DEPARTMENT OF PUBLIC WORKS COUNTY OF HUMBOLDT

LAND USE DIVISION INTEROFFICE MEMORANDUM

**RE: SUBDIVISION REQUIREMENTS - IN THE MATTER OF THE VALADAO,
APPLICATION # PLN-2021-17560 FMS, APN 510-381-021, FOR APPROVAL
OF A TENTATIVE MAP, CONSISTING OF 2.47 ACRES INTO 19 LOTS**

These recommendations are based on the tentative map prepared by Kelly-O'Hern dated April 2023, revised December 29, 2023, and dated as received by the Humboldt County Planning Division on December 29, 2023.

Above: Typical section for widening Pickett Road

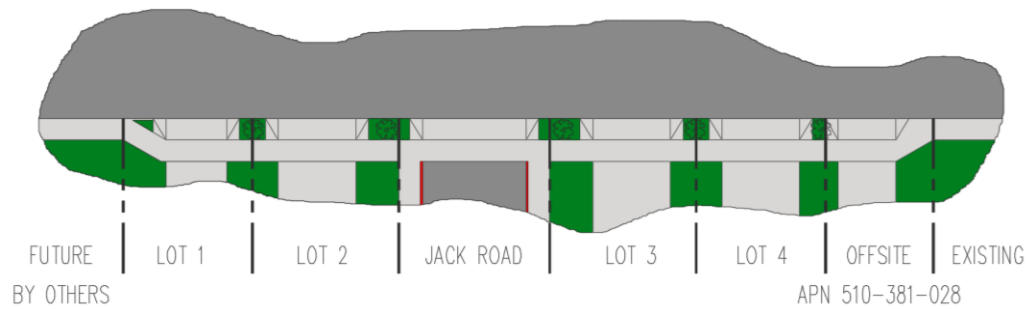
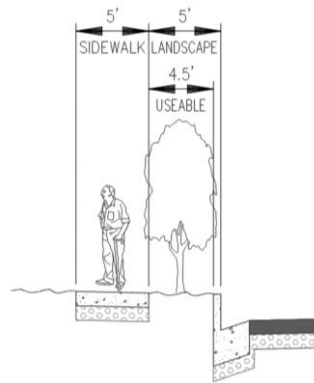
- (a) **Pickett Road (County Road No. 4M030)** shall be constructed having a typical section comprised of two 12 foot wide driving lanes, an 8 foot wide parking lane, a 5' wide landscape strip (4.5' wide useable) and 5' wide pedestrian sidewalk with Caltrans Type A2-6 portland cement concrete (PCC) curb and gutter fronting the subject parcel.

Above: Typical section for widening Gwin Road

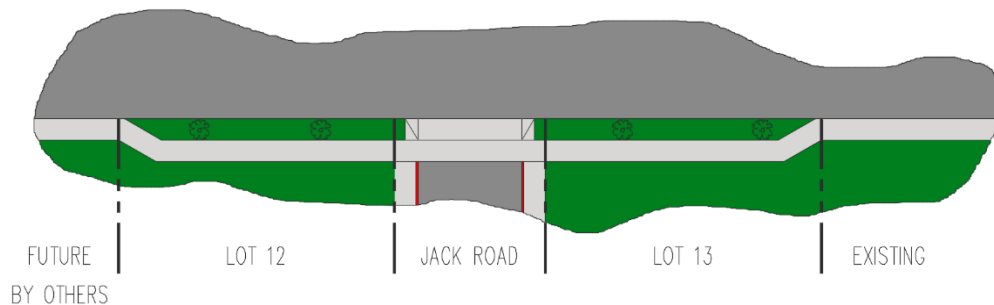
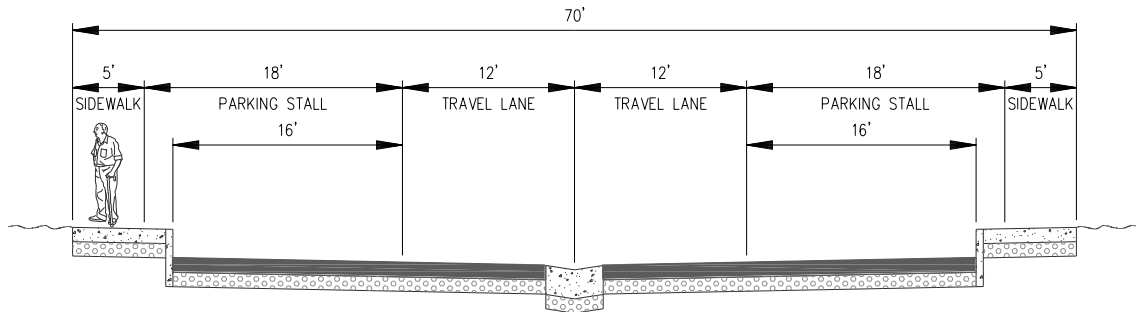
- (b) **Pickett Road (County Road No. 4M030) OFFSITE:** construct in fill curb, gutter, sidewalk, and urban driveway No. 1 across the frontage of APN 510-381-028. (This was the former access to the subject property.)
- (c) **Gwin Road** shall be constructed having a typical section comprised of two 12 foot wide driving lanes, an 8 foot wide parking lane, a 5' wide landscape strip (4.5' wide useable) and 5' wide pedestrian sidewalk with Caltrans Type A2-6 portland cement concrete (PCC) curb and gutter fronting the subject parcel.

Above: Typical section for Jack Way

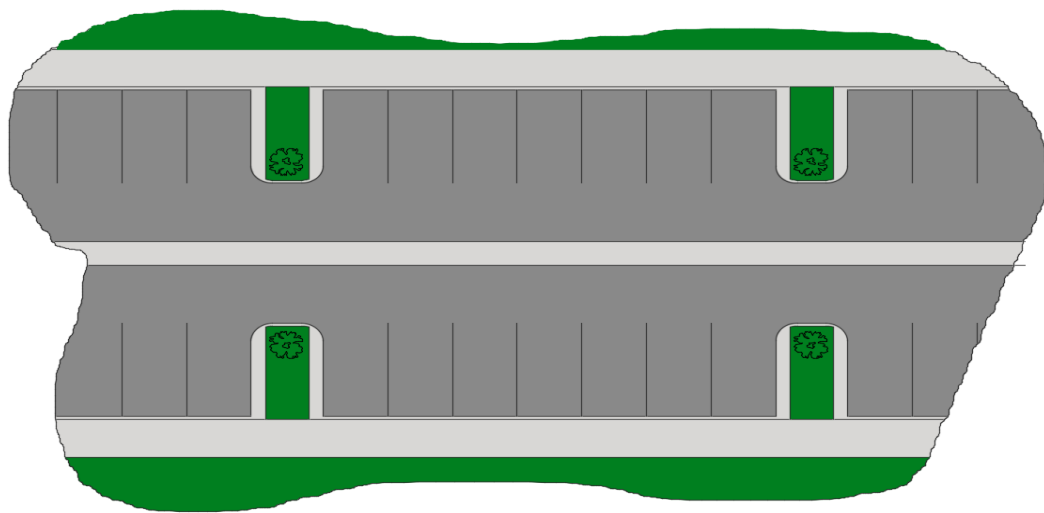
- (d) **Jack Way** shall be constructed 24' in width with a 3' wide concrete valley gutter in the center of the roadway. A 5' wide sidewalk shall be provided along both sides of the road. Where parking stalls are provided, the road shall have a 16' deep parking stall with Caltrans Type A1-6 curb and 7 foot wide sidewalk.

Parking stalls shall be a minimum of 9 feet wide in order to utilize a 24 foot wide roadway. A wider roadway is necessary if narrower parking stalls are desired.

At its intersection with Pickett Road and at its intersection with Gwin Road, construct Urban Dwy No. 1.

The road is not designed for on-street parallel parking. In all areas where perpendicular parking is not provided, the curb shall be painted red or otherwise posted for no parking.

Where perpendicular parking is provided, provide landscaped medians periodically.
